Transmitted by the expert from Sweden

Informal document No. GRSP-41-11
(41st GRSP, 7-11 May 2007,
agenda item 10.1.)

Proposal for draft amendments to Regulation No. 29

Regulation No. 29

Fig. 1

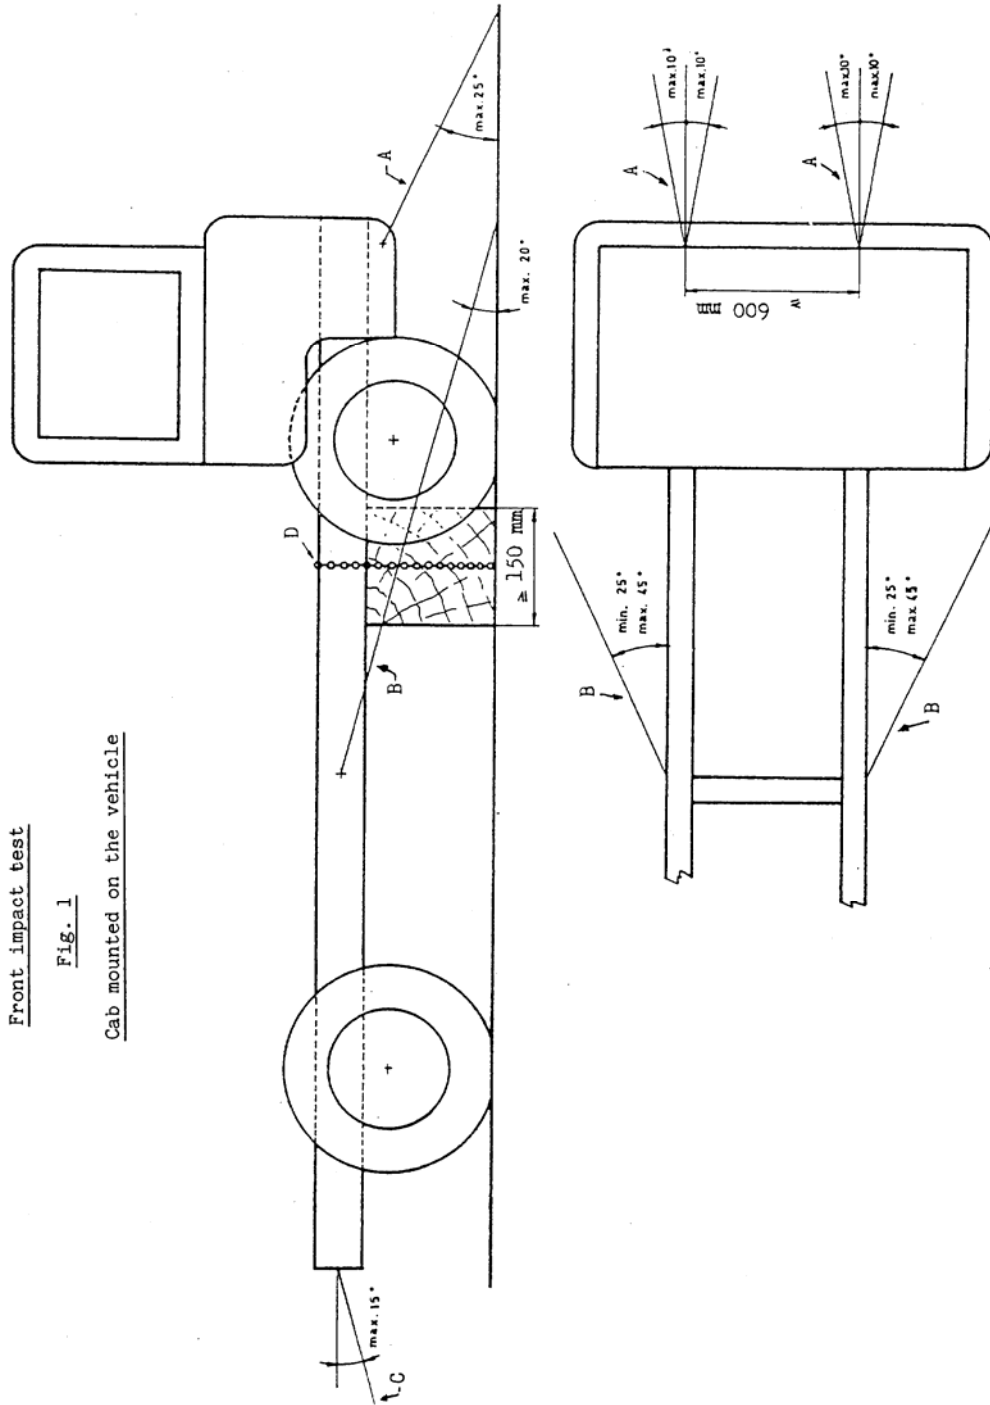
~~1. Frontal impact~~

~~Test A shall be applied to a cab mounted on the vehicle in the following way (see figure 1 below).~~

~~2. Roof strength~~
